UNITED STATES DEPARTMENT OF COMMERCE
Patent and Trademark Office

APPLICATION NO.	FILING DATE	FIRST NAMED INVENTOR	ATTORNEY DOCKET NO.
08/895,936	07/17/97	WISNEIEWSKI	R 17882706

Office Action Summary	Application No.	Applicant(s)	
	Examiner	Art Unit	
	08/895,936	Wisniewski	
	Ford	3743

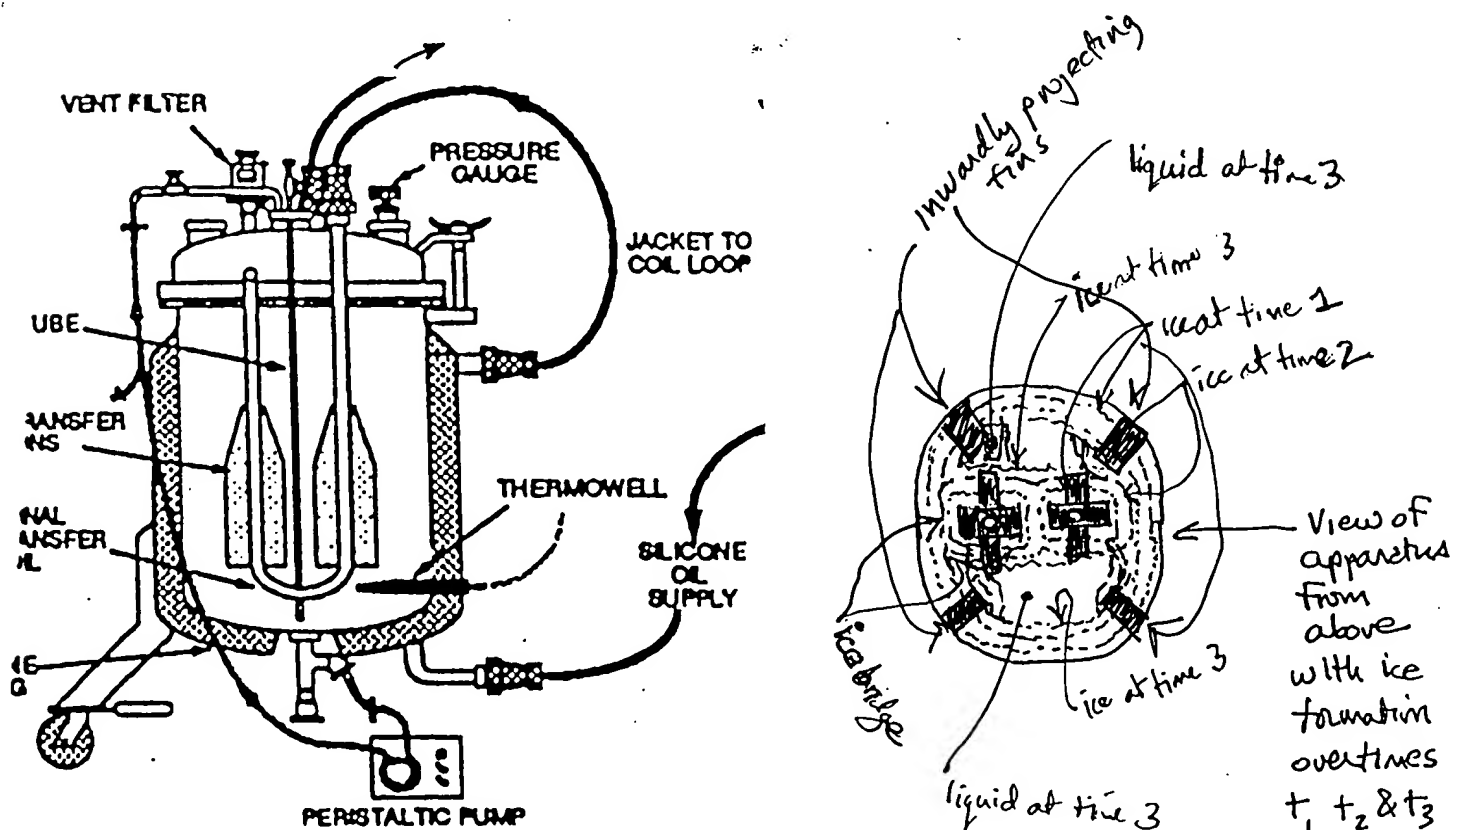
“Whether ice forms in single cakes about several freezing elements or forms in a single cake inclosing a plurality of such elements depends upon the spacing of the several freezing elements from each other. In the first instance of course, ice forms separately about each freezing element, but if these elements be *close together* the ice surrounding these elements will soon *coalesce into a single cake*; and after this has occurred freezing will go on from the surface of the combination cake so formed.” (Emphasis supplied).

“I have shown a number of other elements so spaced relatively as to form a single cake 15 of length comparable to cakes formed in plate processes. Of course if the *freez-ing were continued indefinitely the cakes 12, 13, 14 and 15 would eventually coalesce and freeze to the sides of the tank....*”

It is evident that ice will build up on the heat exchanger and walls of the vessel shown in Figure 1 of 1992 Wisniewski and Wu research paper, during the freezing phase, until they bridge as shown in the diagrams below, a fact that can be established by basic scientific principles. Burroughs et al. USP 3,318,105 illustrates the phenomena. As is clearly seen in Figs. 1A-1C ice builds up evenly on cooled surfaces and even as the top surface freezes the ice coating on the submerged surfaces continues to build up more or less evenly. The same type of analysis is disclosed by Finnegan USP 2,129,572, illustrating that the time required to freeze a substance varies “approximately as the square of the thickness of such substance” with slower freezing generally leading to undesirable concentration effects (what applicants and the 1992 Wisniewski
